RE: VGT Phase I SUP Application #2009-01P

Re: Village at Grand Traverse – Phase 1 Site Plan – 3rd Review
OHM Job No. 0237-09-0030

VILLAGE OF GRAND TRAVERSE, L.L.C.
THE VILLAGE AT GRAND TRAVERSE PHASE I
 OVERALL PHASE I SITE PLAN - P.C. PH I RECOMMENDATION SUBMISSION
 SECTION 2, TOWN 27 NORTH, RANGE 10 WEST
 ACME TOWNSHIP, GRAND TRAVERSE COUNTY, MICHIGAN

VILLAGE OF GRAND TRAVERSE, L.L.C.
THE VILLAGE AT GRAND TRAVERSE PHASE I
PHASE I CORRIDOR LANDSCAPE PLAN - P.C. PH I RECOMMENDATION SUBMISSION
SECTION 2, TOWN 27 NORTH, RANGE 10 WEST
ACME TOWNSHIP, GRAND TRAVERSE COUNTY, MICHIGAN

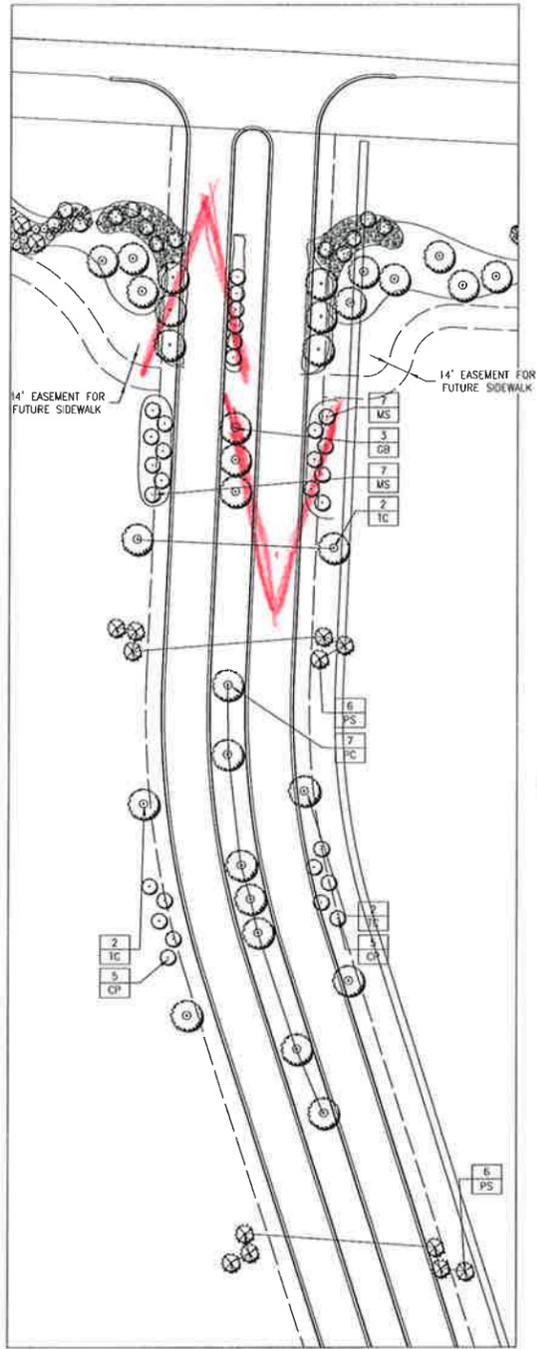
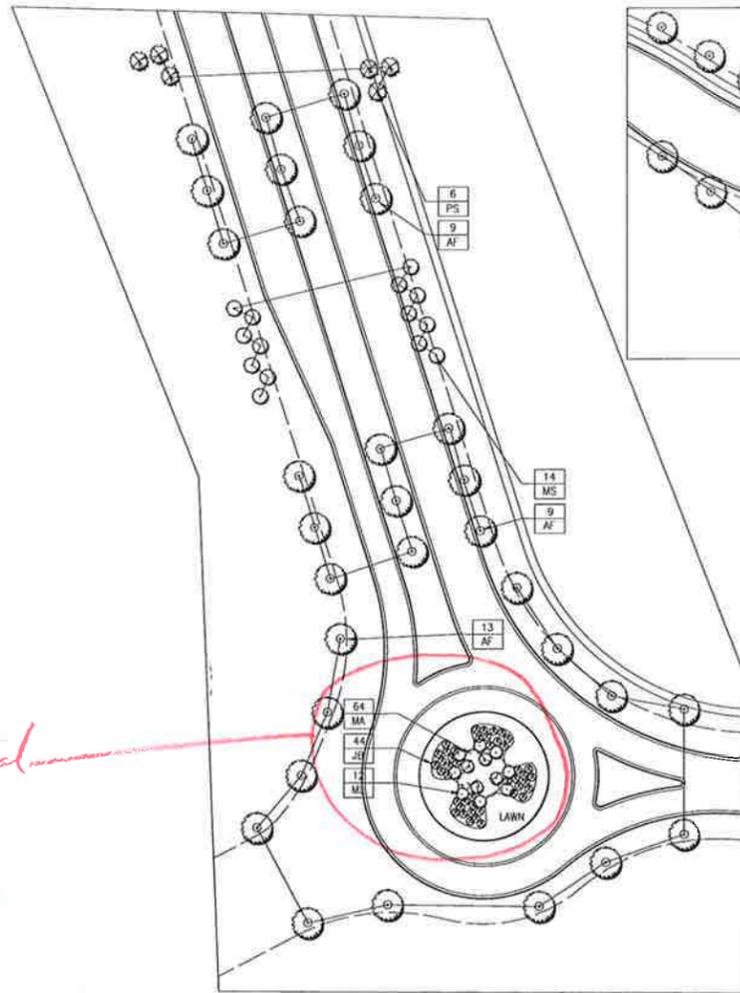
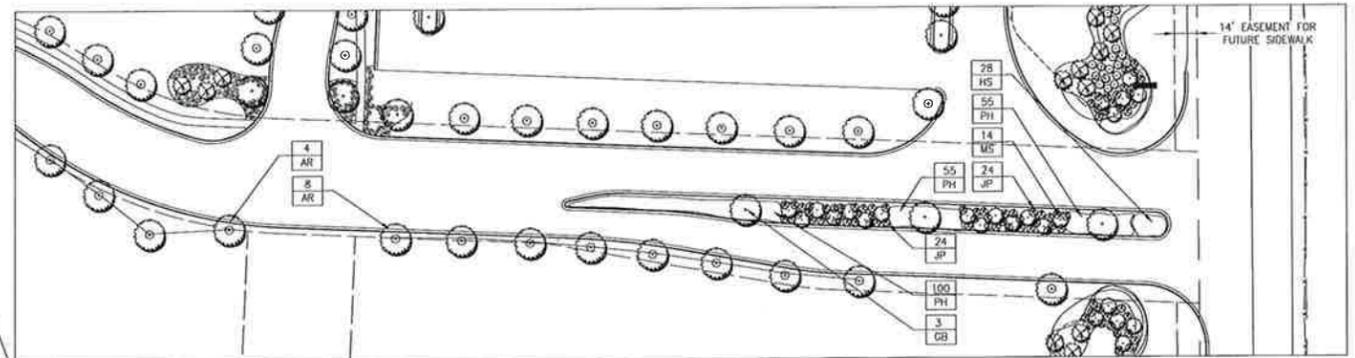
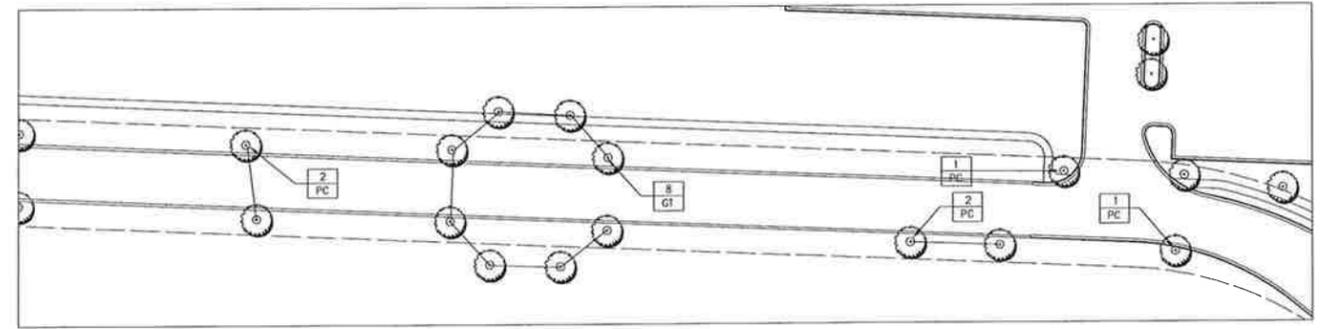
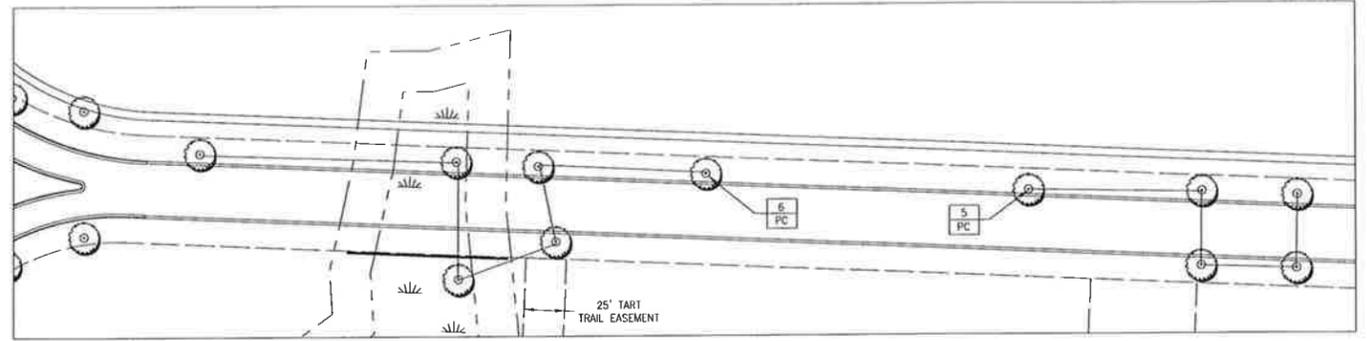
- ▼ The landscaping shown within the central island of the roundabout is acceptable. In fact, it would be OK to add canopy trees to the plan, so long as they are kept from the edges (near the truck apron). Be sure to mound up the central island to enhance visibility of it for approaching traffic.

Be sure to mound up central island. OK to use canopy tree(s) if kept away from edges.

Section 6 GRAPHICS/SIGNAGE DESIGN GUIDELINES – Commercial Buildings

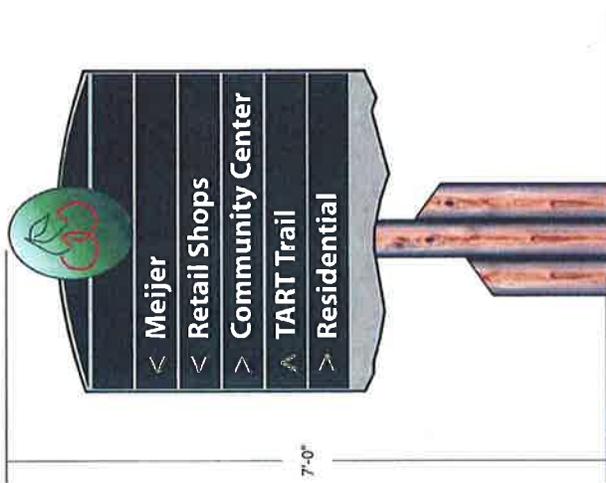
- ▼ Exhibit 1-A(3) – The wayfinding or directional signs shown do not conform to the MMUTCD. Problems include: lettering font and size, arrow style and placement, number of destinations (messages) on one sign, and whether the sign will be made with an appropriate type of retro-reflective sign sheeting so will be visible at night under vehicle headlight illumination. See Sect. 2D.50 (pages 172 to 178) of MMUTCD on correct requirements and guidance for wayfinding signage.

*These do not conform to MUTCD
See Sect. 2D.50 for Info. on
Wayfinding Signs (pg. 172 - 178)*

Potential issues: lettering size, arrow style, placement, number of destinations on 1 sign, whether lettering/background is retro-reflective (minimum strength) ...

Add
Traffic Control Signs shall conform to Michigan Manual on Uniform Traffic Control Devices, 2011 Edition, regarding their design, usage and placement.
